SERVICE BULLETIN

Replacement of the overload clutch of ROTAX® Engine Type 914 (Series)

ATA System: 72-00-00 Engine

Replacement of the overload clutch of ROTAX® engine type 914 (Series).

Fig. 1
overload clutch

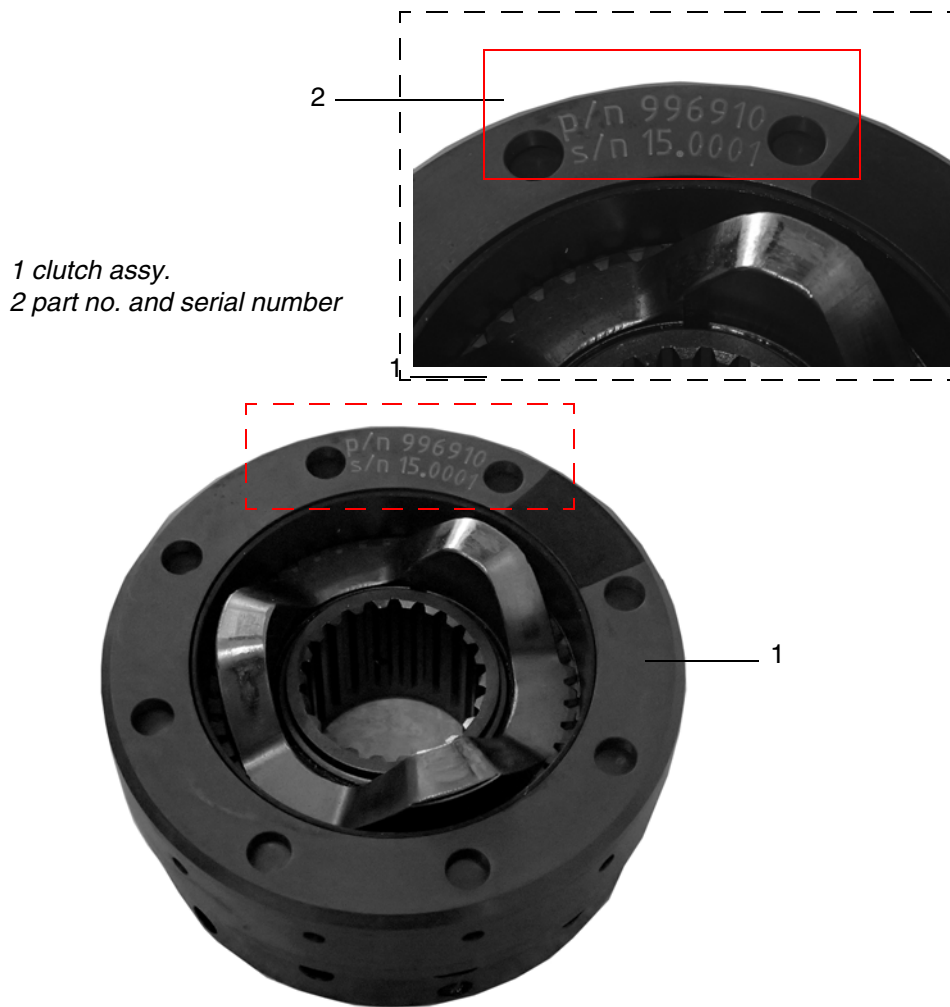
For all engines of the engine type 914 (Series), which are not affected by criterion A and/or B, overload clutches with labeled part no. and S/N on the housing must be used at an future replacement of the clutch assy.

NOTE: Spare parts labeled with part no. and S/N will be available from the date of this Service Bulletin. See Fig.1
